Amendments to the Drawings

REMARKS/ARGUMENTS

ANNOTATED SHEETS SHOWING CHANGES

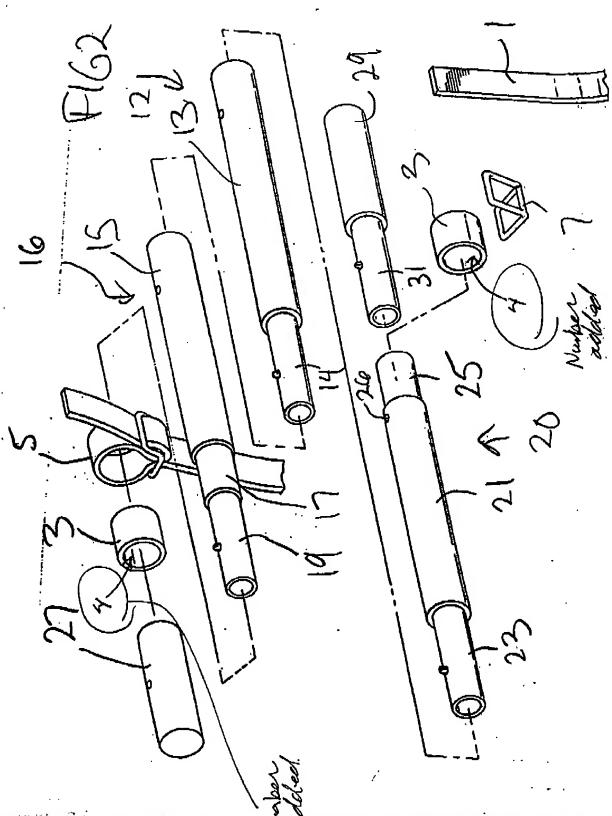
The attached sheets of drawings include changes to Figures 1, 2 and 7. These sheets replace the original sheets including Figures 1, 2 and 7. Each of these Figures 2 and 8 include identification of the central securement port 4. Certain lead lines in Figure 1 have been corrected or removed.

In the specification paragraph [0018] has been amended to identify the central securing port 4. Figures 1, 2 and 8 have been amended. Figure 1 has been amended to identify or remove unlabelled head lines. Figures 2 and 8 have been amended to identify the central securement port 4.
